DEVELOPMENT REVIEW COMMITTEE (DRC) COMMENT REPORT

PROJECT NAME: Riverside Residences

CASE NUMBER: UDP-S23058

REQUEST: Site Plan Level II Review: 14-Unit Townhouse
Development

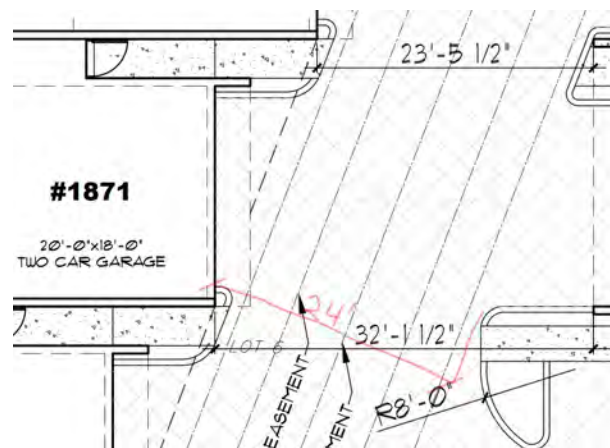
8. The proposed driveway approach (withing right-of-way) shall remain perpendicular to the roadway centerline.
9. For surface or ground-level parking lot layout:
 - a. Drive isle a parking or a unit garage shall he a minimum width of 20 feet.
 - b. Per ULDR Section 47-20.11.A, drive aisle width shall be 24' (min.) adjacent to 90-degree angle parking stalls. The criteria also applies to the areas immediately exiting the individual unit garage as picture below.
